Planning and Zoning Commission

February 5, 2019

Dallas Center – Grimes Middle School – Site Plan

FOX Engineering has completed the second review for the DC-G Middle School Site Plan dated January 29, 2019. Please address the following comments:

Walmart Building Color Revisions – Minor Site Plan

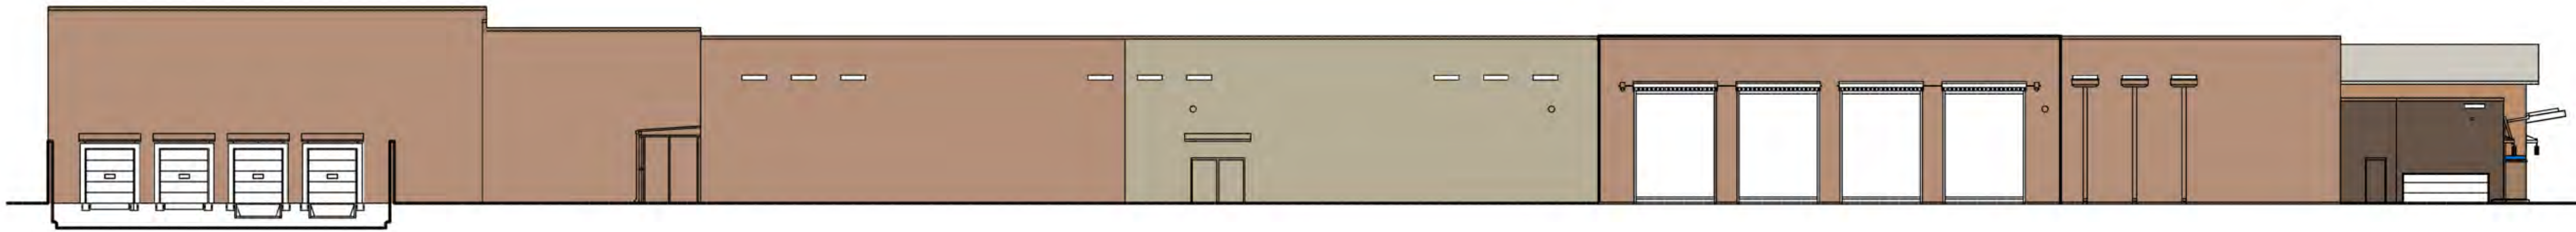
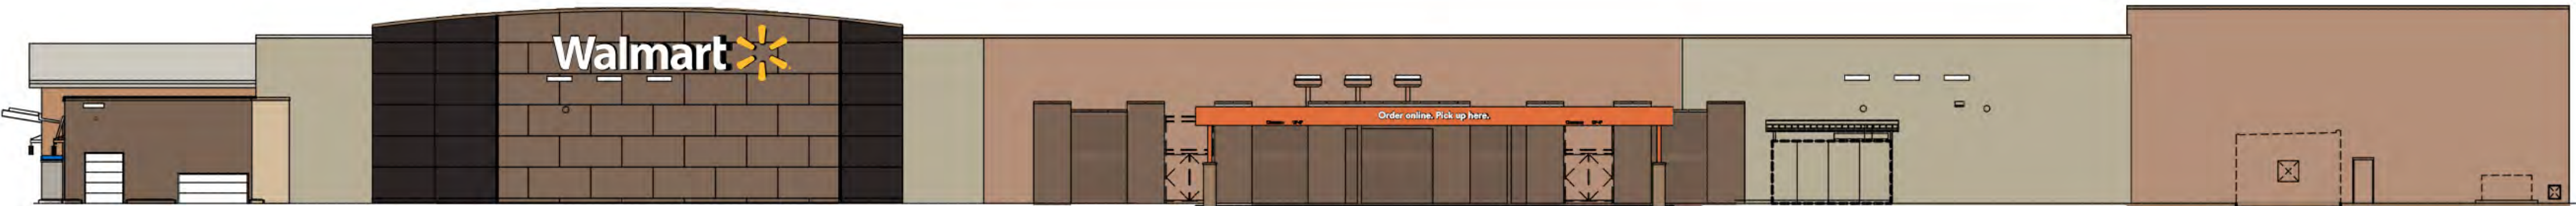
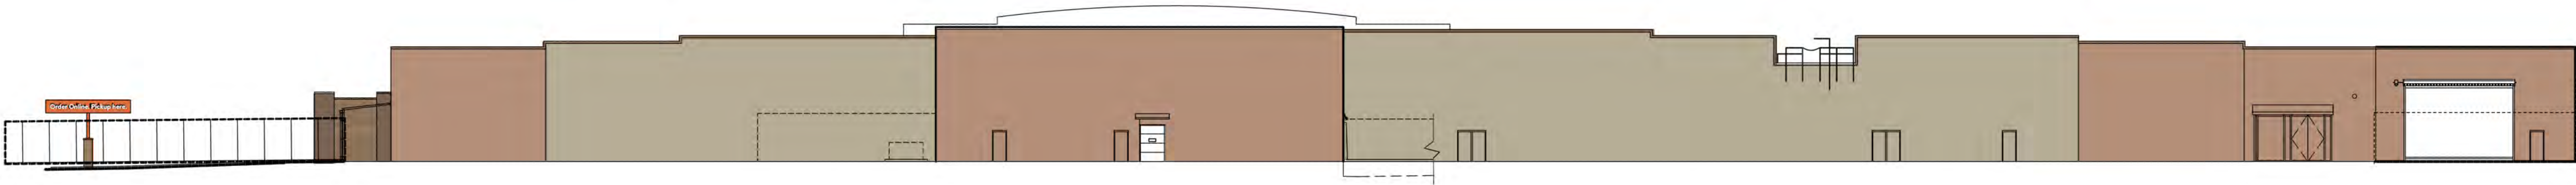
1. The Developer has submitted the application form and \$550 application fee to the City of Grimes.
2. Walmart is proposing to revise the color of their wall signage along the north side of their building. Walmart is proposing adding their national franchise Walmart blue (3M Film) to their signage. According to the HWY 141 Zone 1 ordinance; "SIGN DESIGN. In Zone 1 and Zone 2 all signs shall consist of an earthtone color with the only exception being signs that consist of inflexible National Franchise or Trademark Logos and colors." The Zoning Administrator has reviewed the code, consulted with other neighboring jurisdictions and has determined that this proposed revision of adding blue is part of their national franchise signage. The Grimes Code limits the amount of wall signage to 10%. Walmart has provided documentation that the addition of the blue along with all other existing signage does not exceed the code requirement of 10%.

3. Walmart is proposing to revise the color of the "Order online" canopy from brown to knockout orange (national franchise orange) along the west side of their building. The knockout orange appears to be an earthtone color which is allowed per the Zone 1 code for building materials.

DRAWING NO.:
C-101

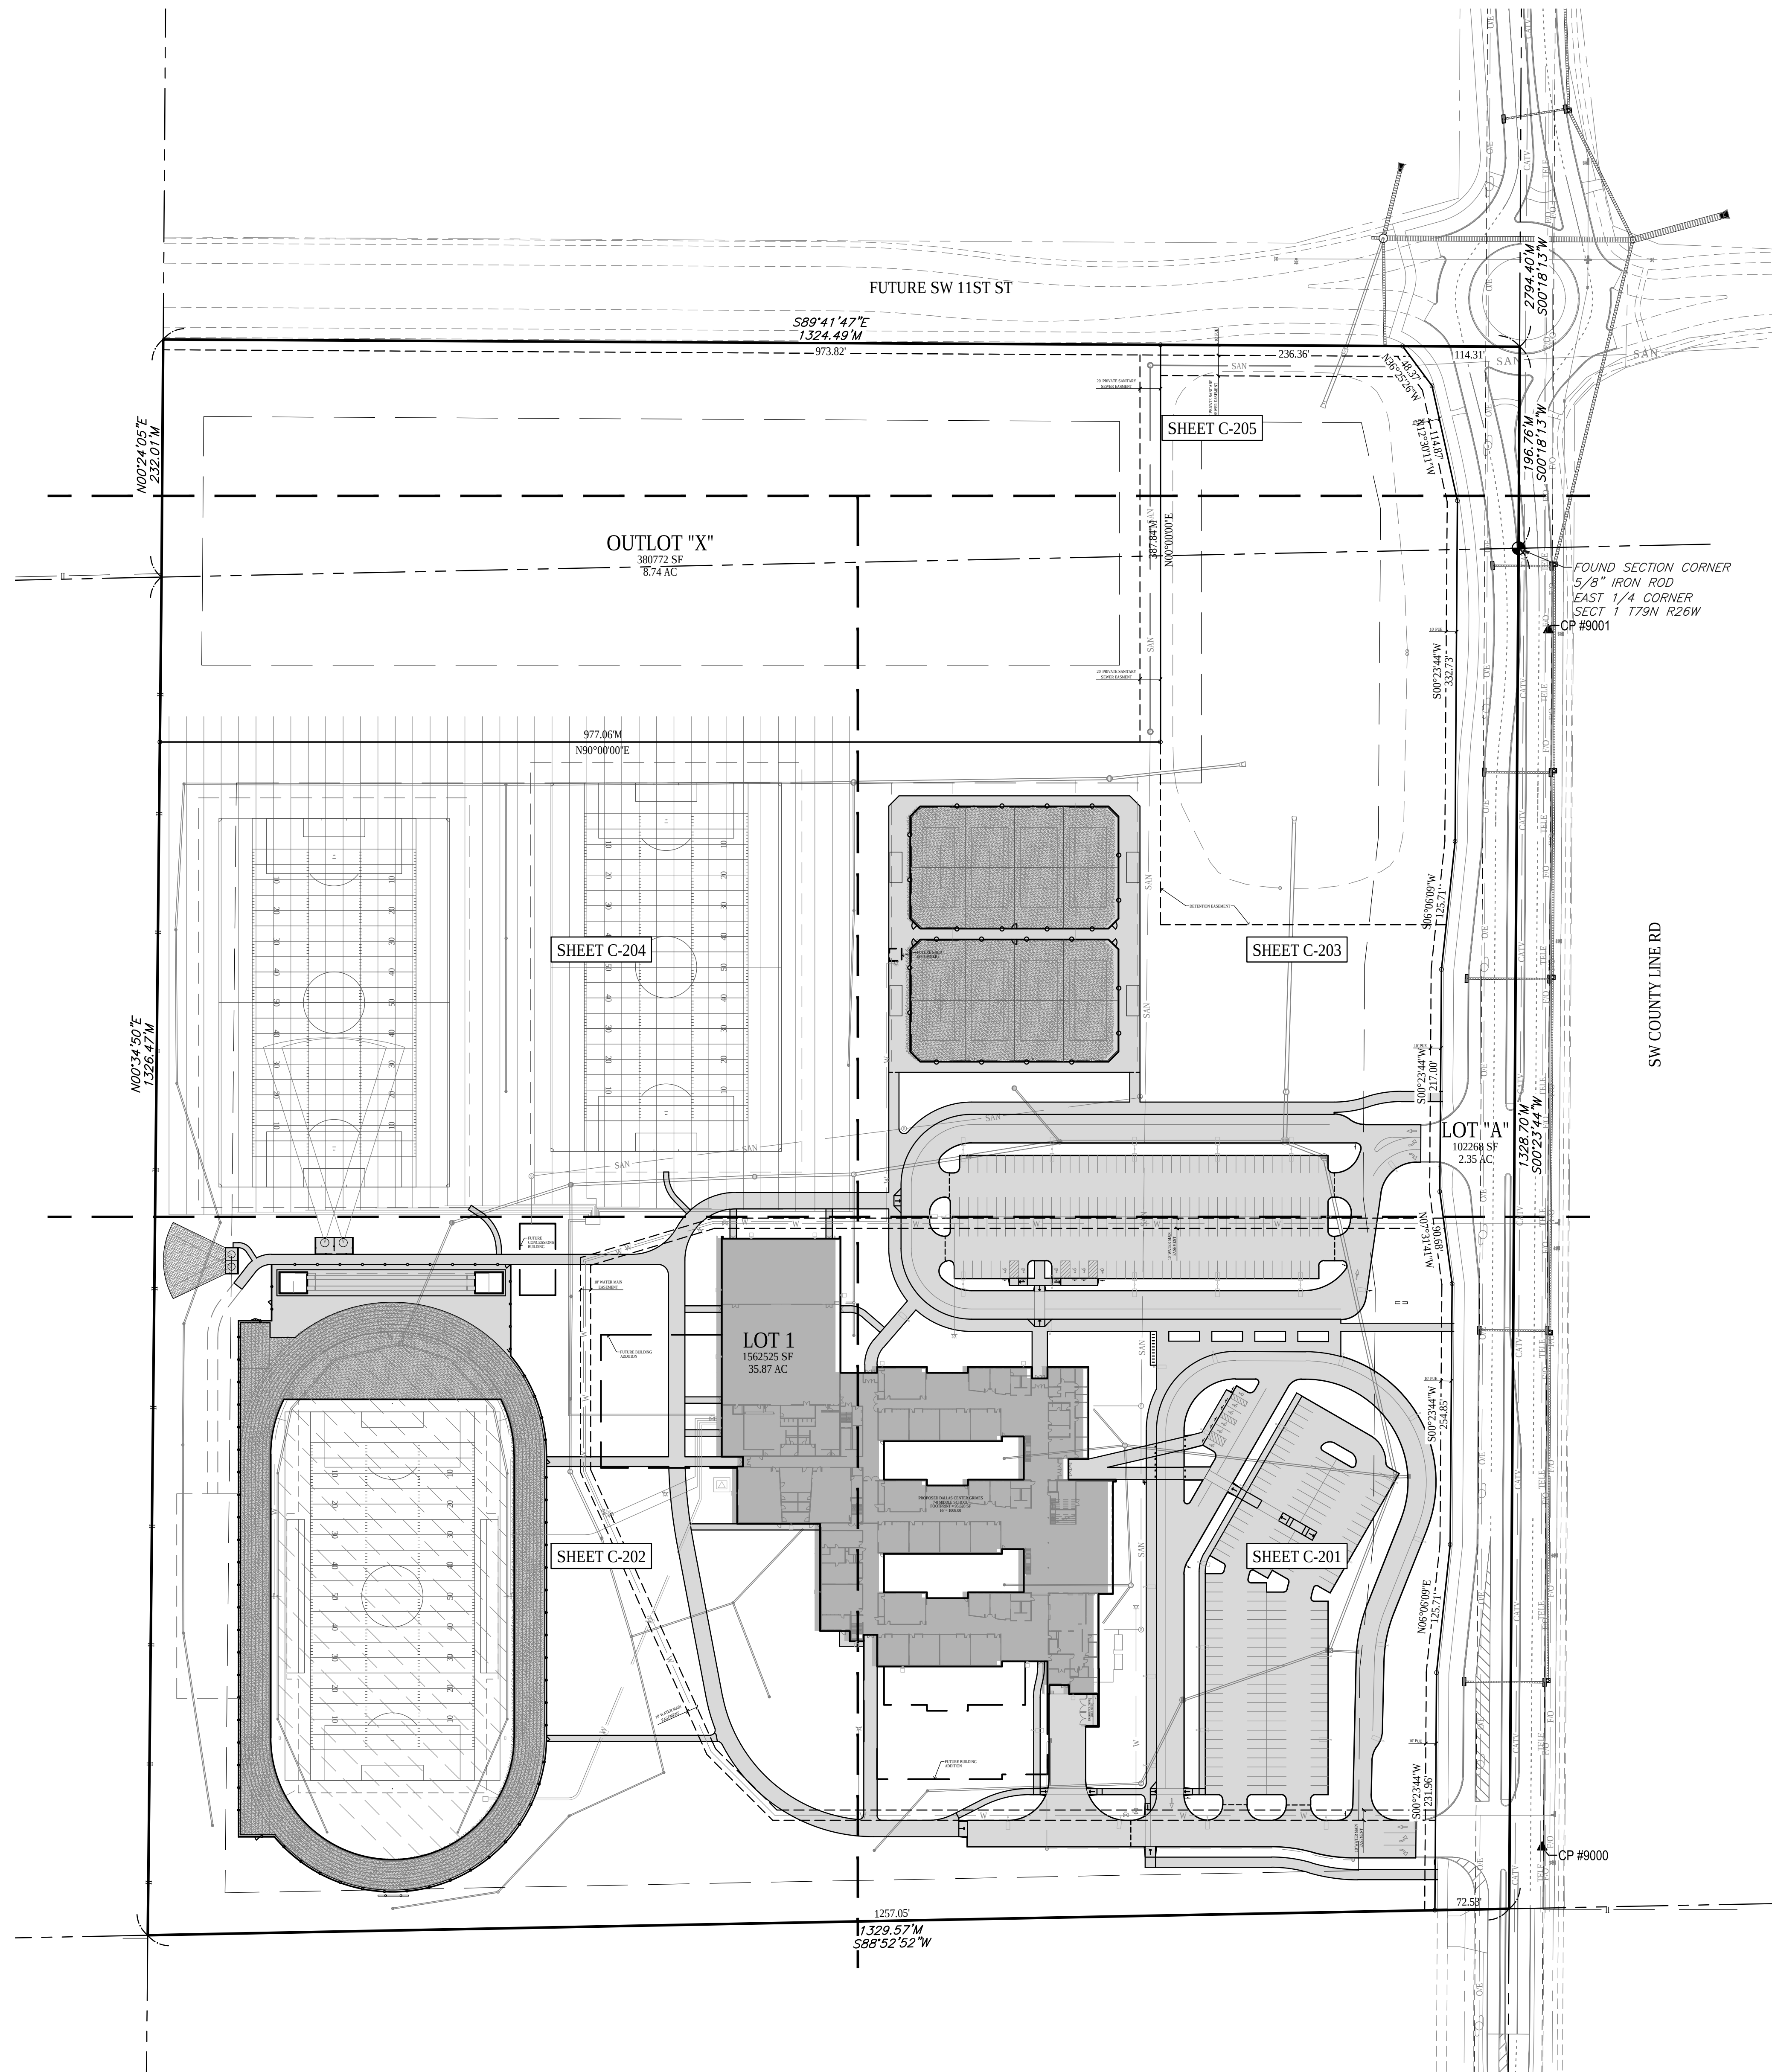
Phasing Plan - Sheet C-101

4. Please provide street naming on this sheet.
5. Please revise Phasing Note 1 to provide the proper sheet number.
